Addendum No. 1

**For Project No. ENG2603736023
Spud Run Culvert Replacement
Potato Creek State Park
St. Joseph County, IN**

ISSUED FROM: Engineering Division Dept. of Natural Resources

ISSUE DATE: November 10, 2025

Exhibit A

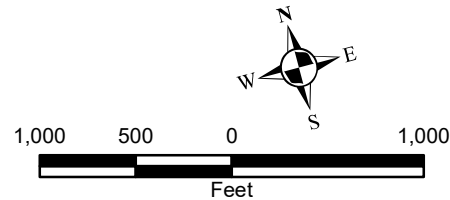
- a. Contractors are advised that they may use any grass or road area behind the road closure points marked on attached Exhibit A.
- b. Contractors should plan to video the haul route for equipment operations entering the park prior to mobilization to document the pre-existing condition.
- c. Contractor will be responsible for fixing damage that occurs during construction to restore to the pre-existing condition.

- a. Contractors are advised that they must provide road closure barricades at the point of the road closure on either end shown in Exhibit A.
- b. Park staff will communicate the traffic detour online, including specifying which facilities are accessible via the south versus the north detour.

DETAIL 2
10' MANUAL SWING GATE
Not to Scale

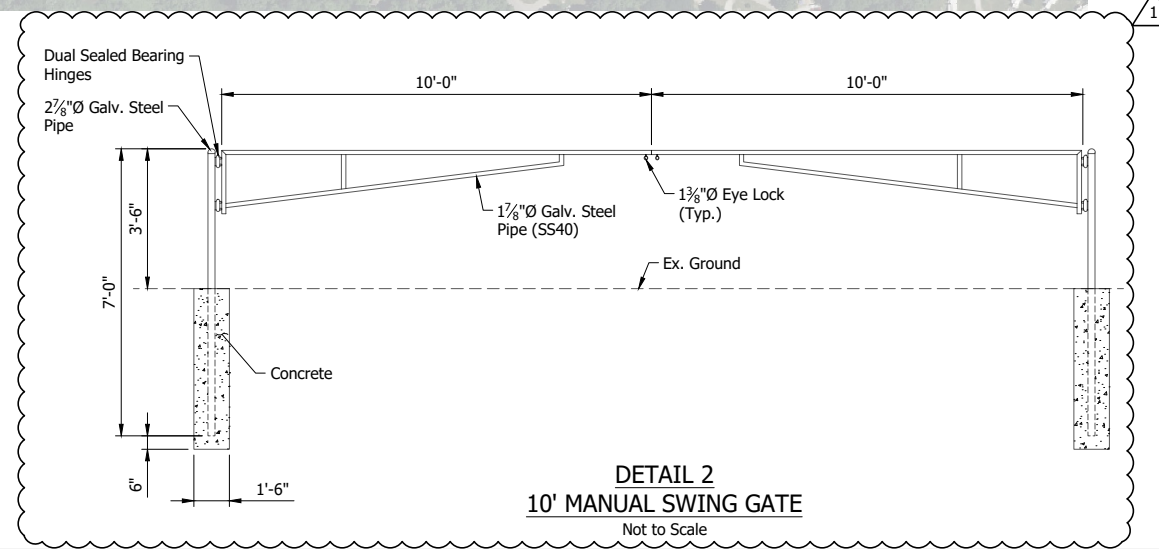
ITEM No. 3 - REVISED PLAN SHEET – ALTERNATE 1: Plan sheet now includes installation of a gate at the north entrance.

- c. The contractor is advised that the Alternate 1 bid items shall now include installation of gates at the north entrance. Gates shall be Galvanized Sentinel Manual Single Leaf Swing Gates, or approved equal, as shown on the Plans
